STATEMENT OF ENVIRONMENTAL EFFECTS

Section 4.55 application to facilitate minor design changes to the approved dwelling at No.41 Marine Pde , Nth Avalon .

Prepared: Nov, 2018

Job No. 16104

The modified ground floor plan layout.

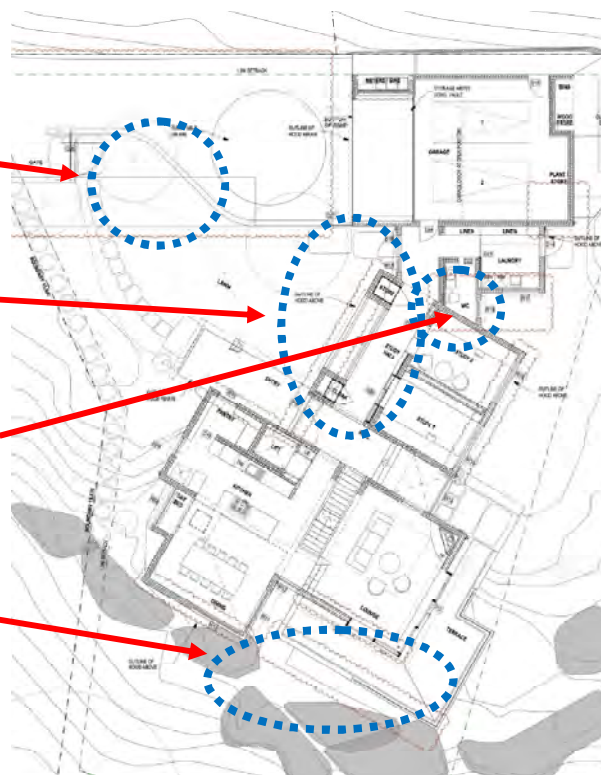
Additional landscaped open space created as a consequence of the curved courtyard wall

A cloak room & store are provided internal to the dwelling, the space in between is now external landscaped open space

The approved W/C is increased in size

N/W facing terrace adjacent to the lounge room has been reduced in width

The modified garage layout.

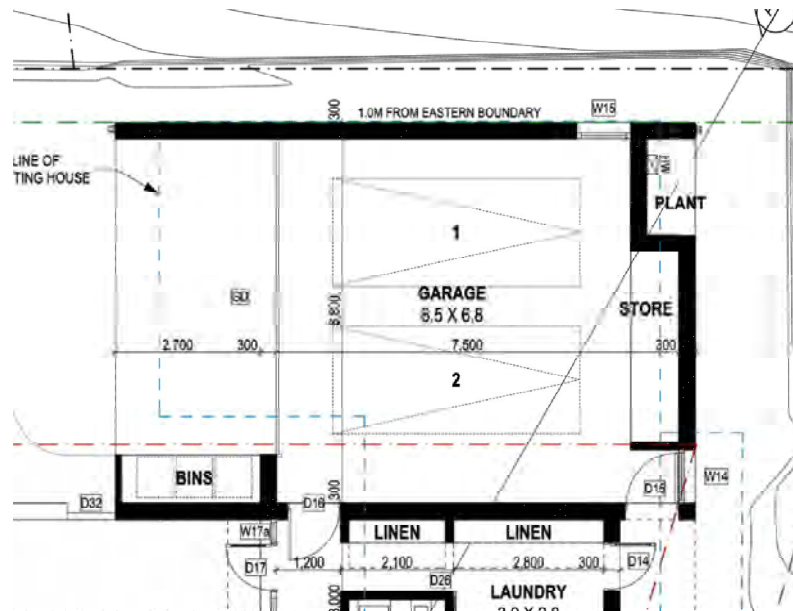
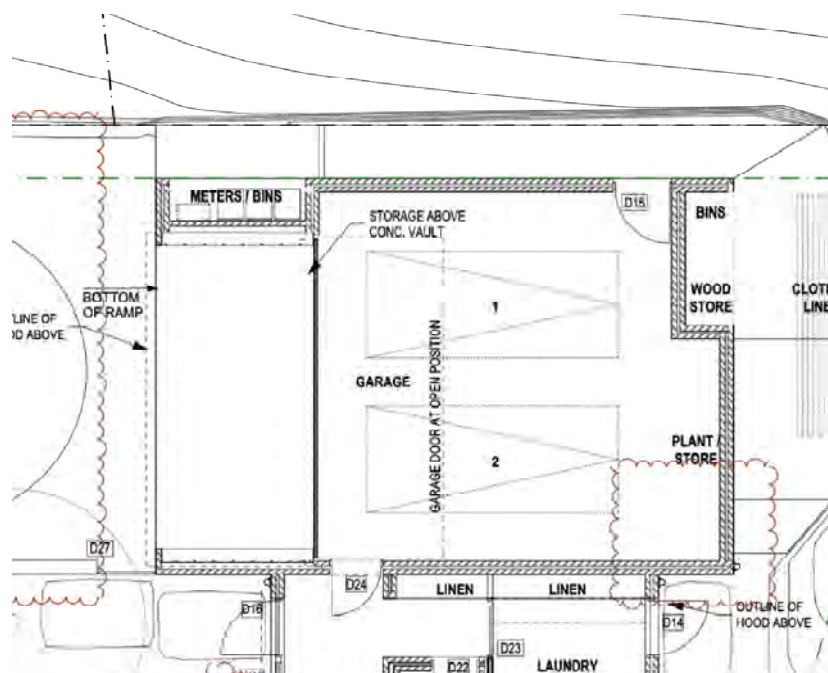
- The internal layout has been altered although it is still a double garage and the approved footprint is unchanged other than for a recess in the eastern wall to accommodate the meter box and the garbage receptacles. Bin storage was previously internal.
- The door at the rear of the garage has been moved to the eastern side
- The roof profile has been altered however still maintains the approved maximum overall height and a parapet has been constructed around the perimeter to conceal the roof mounted solar panels

The modified eastern wall & roof profile of the garage and courtyard wall.

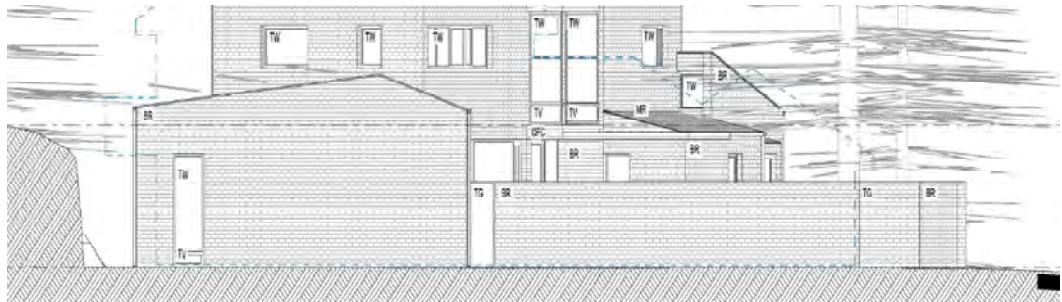
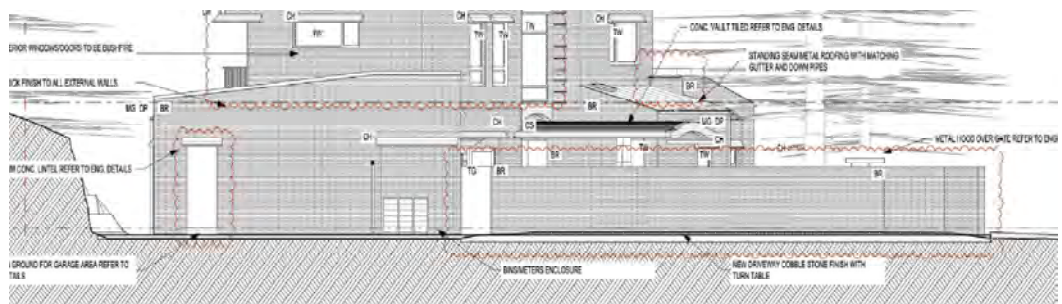
The approved eastern wall & roof profile of the garage and courtyard wall.

The modified window sizes & locations on the eastern elevation of the dwelling.

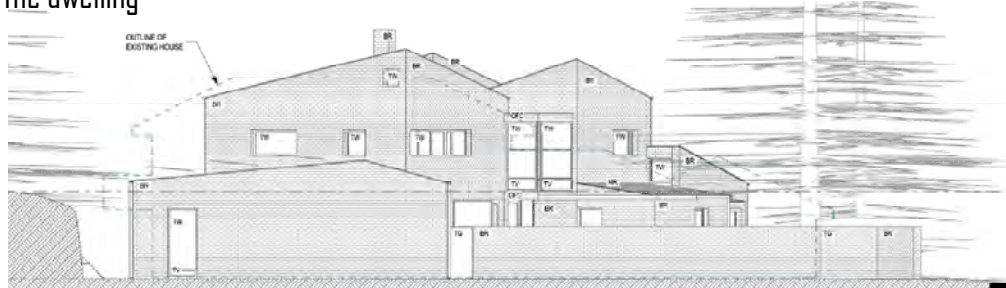
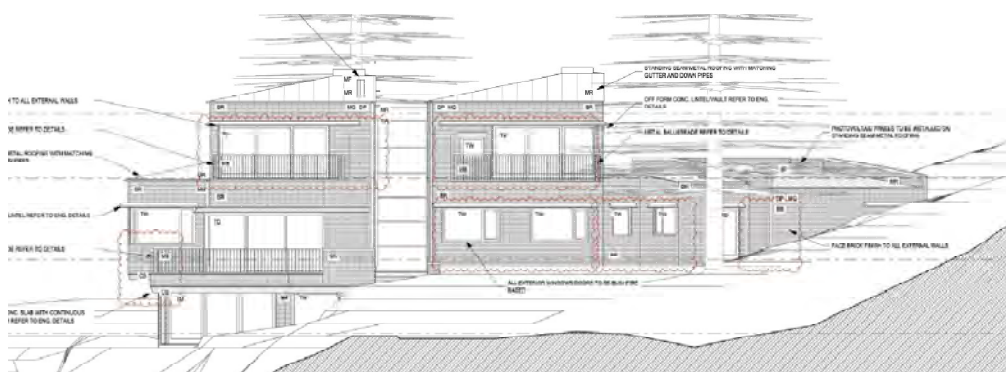
The approved window sizes & locations on the eastern elevation of the dwelling.

The approved window sizes & locations on the southern elevation of the dwelling.

The modified window sizes & locations on the southern elevation of the dwelling.
